Product/Process Change Notice (PCN)

PCN #: PCN_ConWTB254_20160916

Product Affected: 6190xx11021 6190xx19521

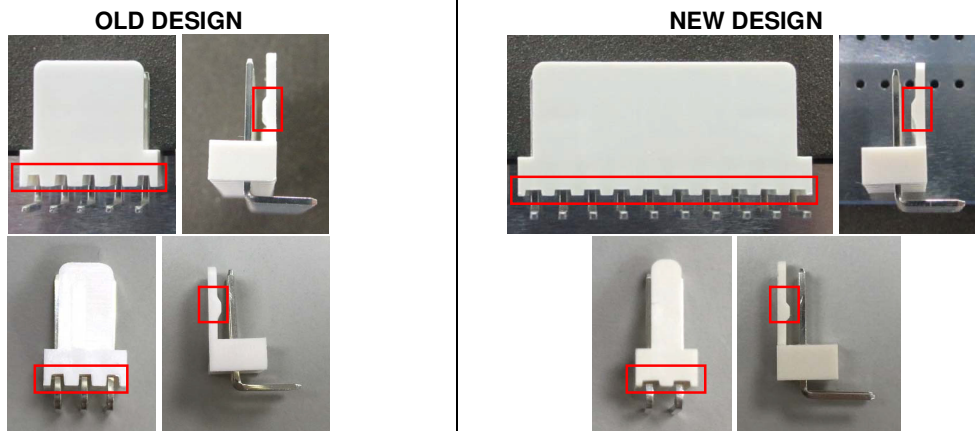
DETAIL OF CHANGE:

The plastic grooves are shallower, the locking tongue base is thinner.
